### Safety Notice (Coal Mining Hazardous Area ONLY)

### <u>Austdac Pullkey – Aluminium Crimp</u>

#### Issue

**PHOTO 1: PULLKEY**

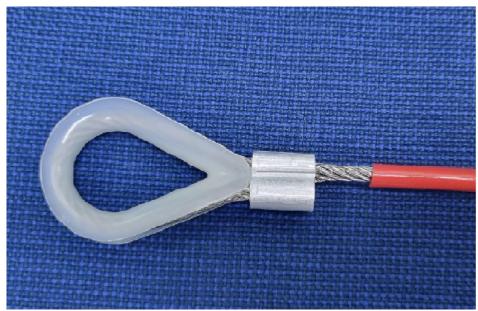
As previously notified Austdac is voluntarily notifying customers that, due to an error by our production partner, certain Austdac branded Pullkey products manufactured between January 2020 and March 2023 may contain an aluminium crimp that is not in accordance with the published product specifications. While Austdac is not aware of any product failures or injuries, we note that per the product specifications, Pullkeys should be fitted with a plated copper or stainless steel crimp.

Photo 1 below shows the location of the relevant crimp. In the event that an aluminium crimp was used on the Pullkey, the crimp will be in the form of a figure 8, as is shown in Photo 2. The plated copper or stainless steel crimp will appear as a hexagonally shaped crimp, as shown in Photo 3.

PHOTO 4: PROTECTIVE COVER SHOWN OPEN.

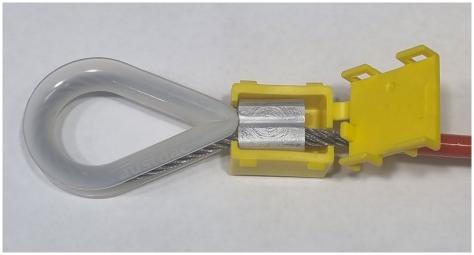
A snap on protective cover has been designed and is shown in photo 4, 5, 6 and 7.

PHOTO 9: PROTECTIVE COVER SIDE WITH CABLE TIE.

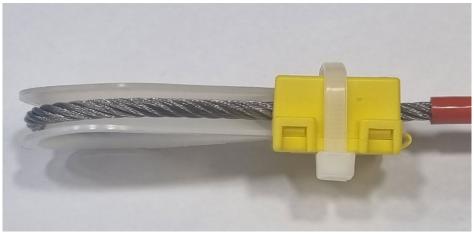
A cable tie may be used for additional security as shown in photos 8 and 9.
